OG-01-035
May 23, 2001

Subject: Westinghouse Owners Group
Transmittal of Approved Version of WOG Aging Management Report,
"Aging Management Evaluation for Pressurized Water Reactor
Containment Structure," WCAP-14756-A (MUHP-6110)

WCAP-14756-A

Aging Management Evaluation for Pressurized Water Reactor Containment Structure

Figure 2-2 Type 2 Containment Cross-Section

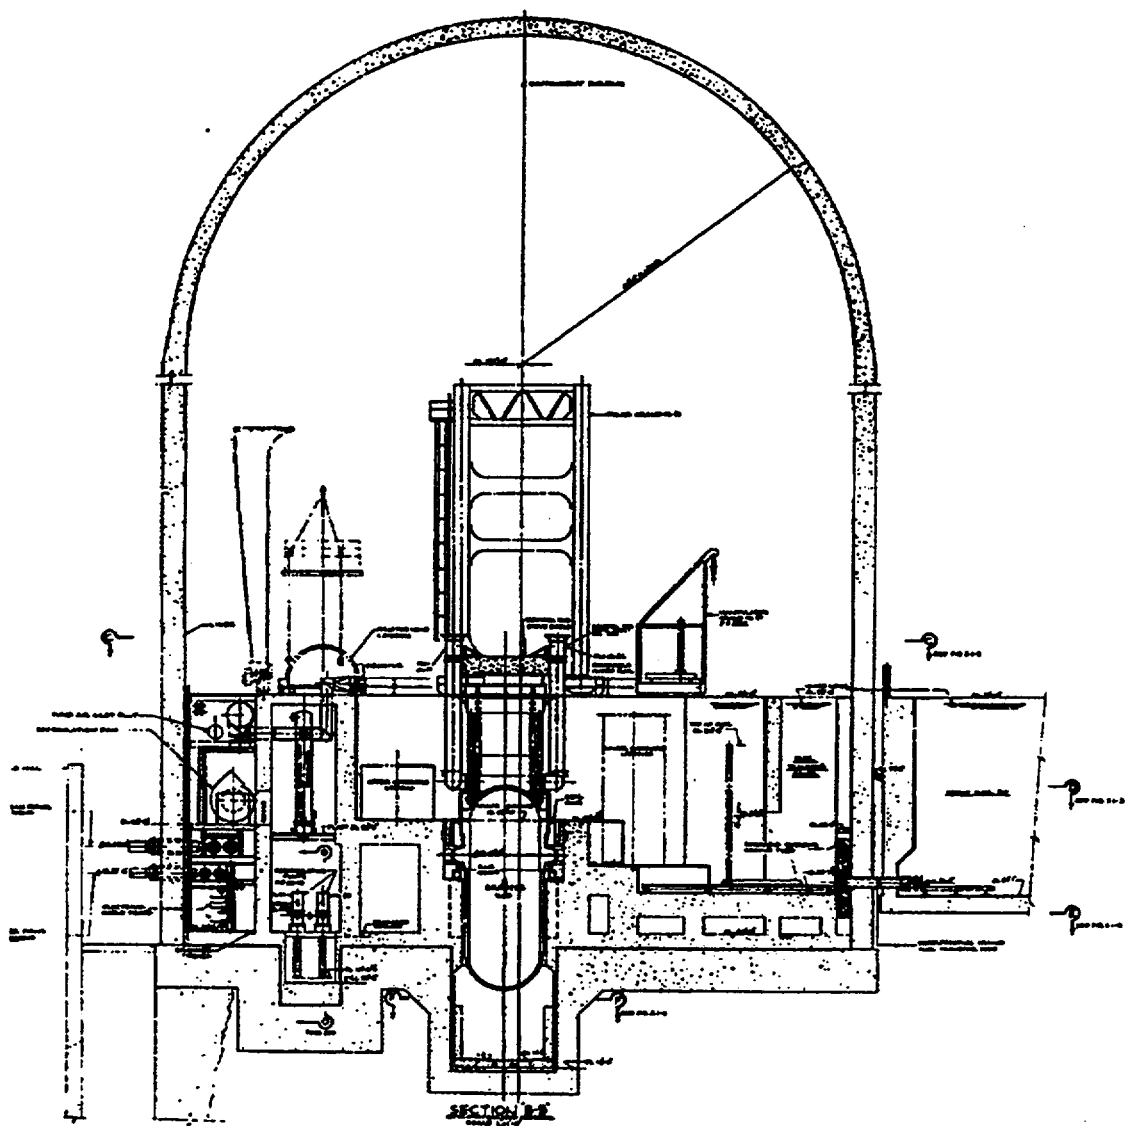
Since many of the sketches of equipment details presented in the GTR are not legible (e.g., Figures 2-2, 2-7, 2-10 and 2-13), the staff requested in RAI No. 32 (NRC letter dated February 19, 1998) that clear and legible figures be provided. In response (letter dated May 29, 1998), WOG indicated that the sketches in the GTR provide overall general characteristics of the different configurations and types, and do not provide details to the level requested in the RAI. WOG indicated that the requested details would be provided as needed as part of the license renewal application. This issue is designated as Renewal Applicant Action Item No. 5.

5. Provide legible drawings of equipment and penetration details as part of the description of the containment structure components.
6. For prestressed concrete containments, indicate whether the tendon access gallery is included as a containment structure component subject to an aging management review. If it is, provide the details of the aging management review and the credited aging management program. If not, provide a technical basis for its exclusion, addressing the potential for degradation of the lower vertical tendon anchors resulting from the environmental conditions in the tendon access gallery.
